An estimation of the maximum allowable
capacities of Pens 3 and 4

IR/L/ME/89/35

SHEFFIELD WEDNESDAY FOOTBALL CLUB
HILLSBOROUGH

Fig 4 CONFORMITY OF WIDTH OF GAPS BETWEEN BARRIERS IN PENS 3 AND 4

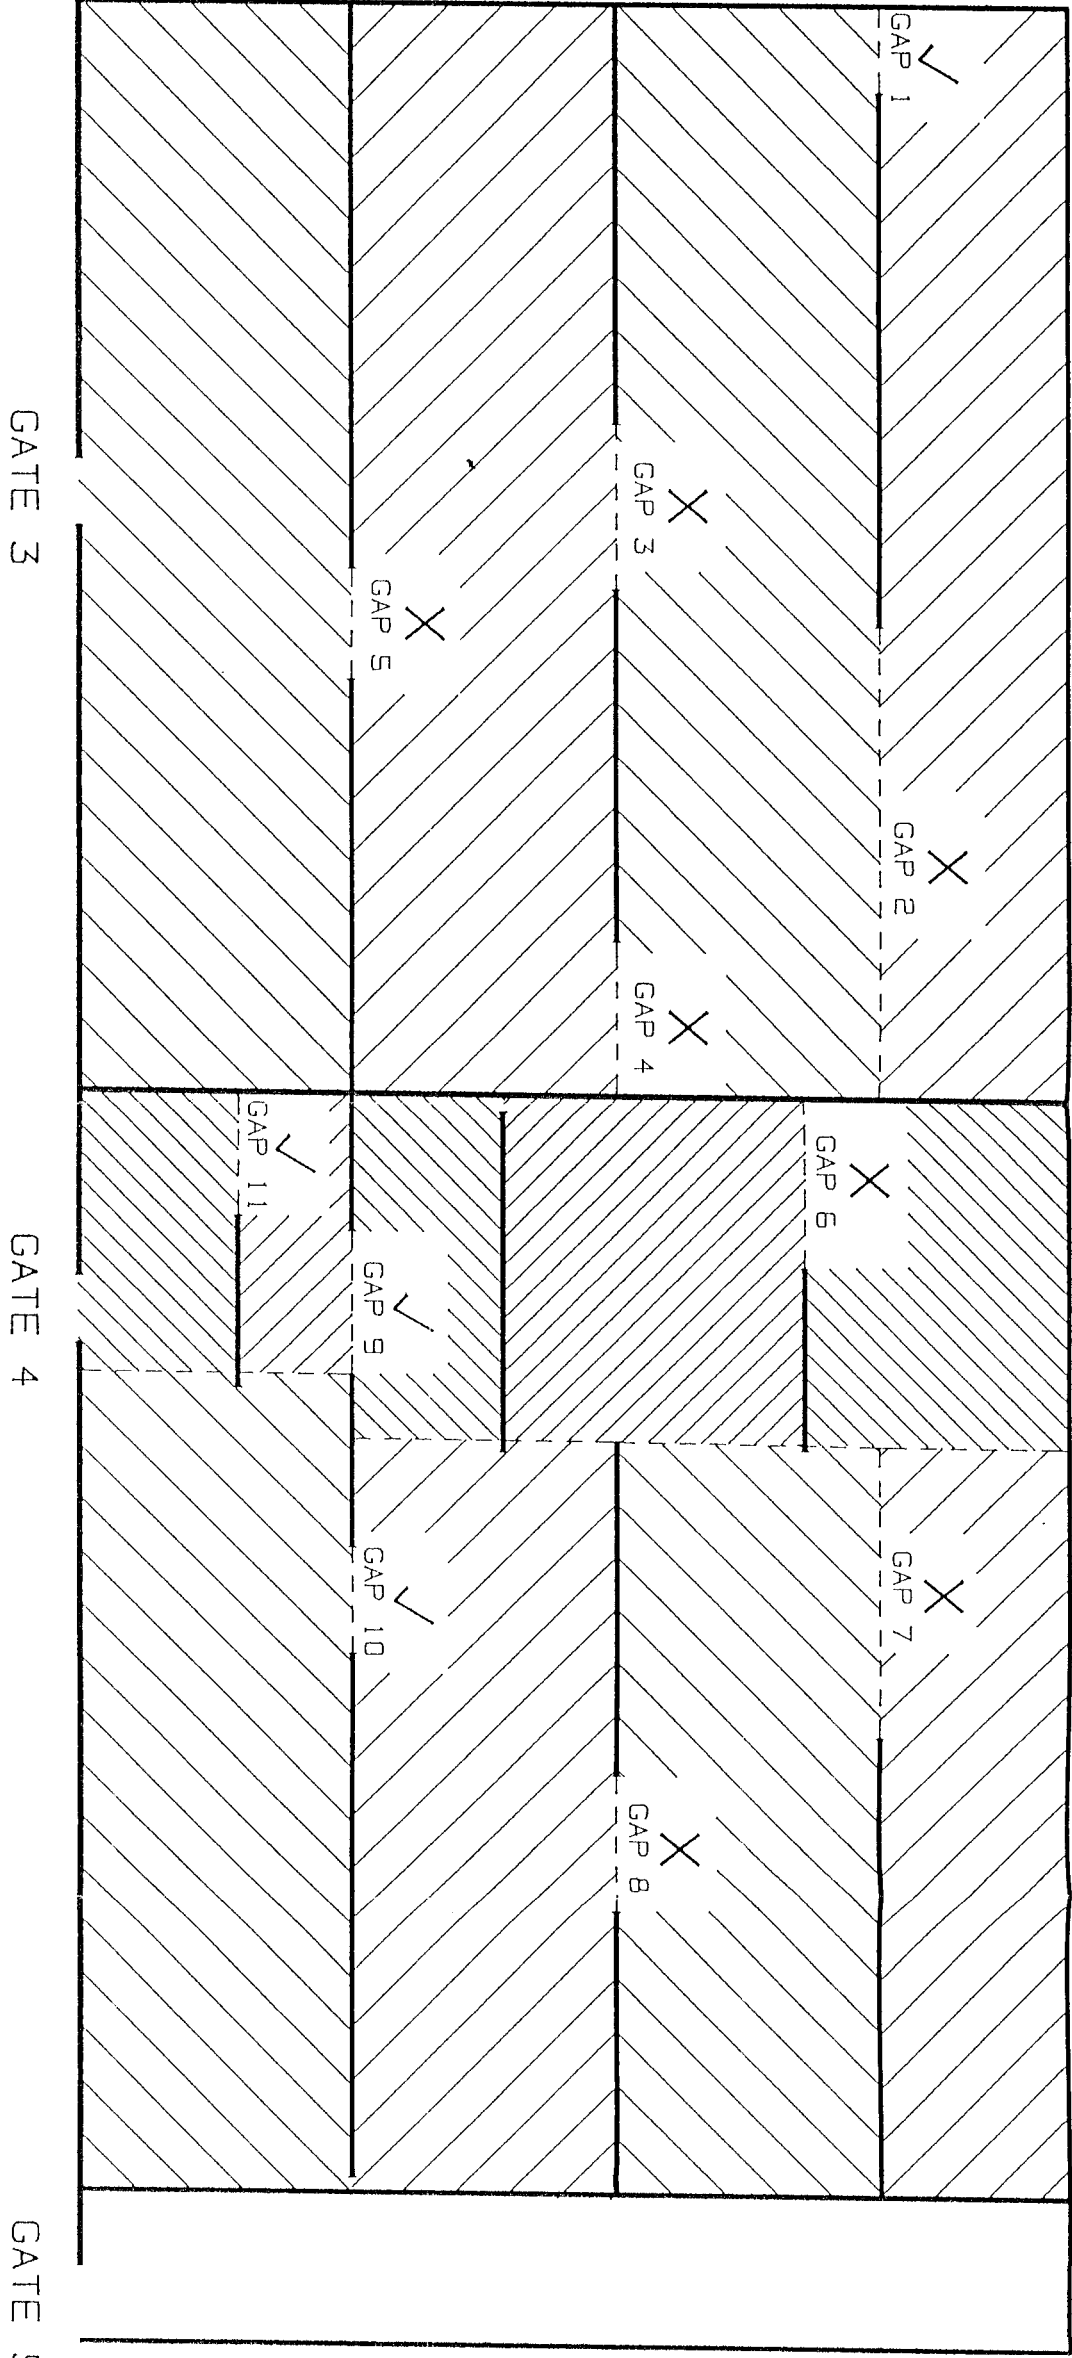
Paragraph 115 - "Where there are gaps in the line of crush barriers these should be at least 1.1 m and not more than 1.4 m in width". Four of five gaps in Pen 3 did not conform and nine of ten gaps in Pen 4 did not conform to a literal interpretation of this recommendation. A more liberal interpretation, relating the acceptability of the width of a gap to the resulting depth of crowd that could form between two rows of barriers, resulted in four of five gaps in Pen 3 and three of six gaps in Pen 4 not conforming, as shown in the schematic plan of Fig 4.
